NOTICE: Notch Rope Runner Pro

The Issue

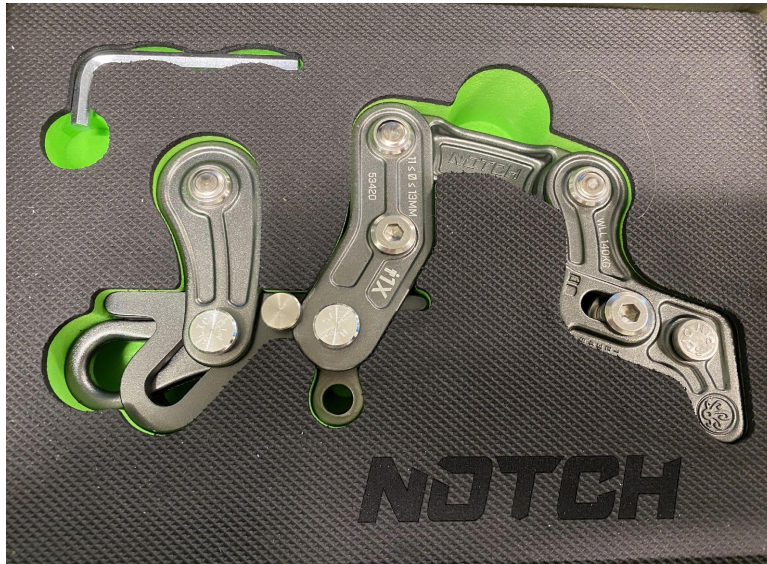
It has been brought to our attention that on a small number of the 53420 Rope Runner Pro devices, the bolt that holds the lever plate stationary during the loading and unloading of the rope, can back out during use.

The issue is not a safety issue, the bolts only function is to hold the lever plate stationary.

This issue should not be present with later serial #'s of the Rope Runner Pro. On 08/20/2020 a change order was issued specifying that a permanent thread locker be added to this part. If you experience this issue with your Rope Runner Pro, it can be fixed by adding a permanent thread locker, such as red Loctite to the bolt, and tightening as tight as possible by hand. Alternatively, the Rope Runner Pro can be returned for repair by contacting info@notchequipment.com or calling (833) 795-0604. Thank you for putting your trust in Notch Equipment.
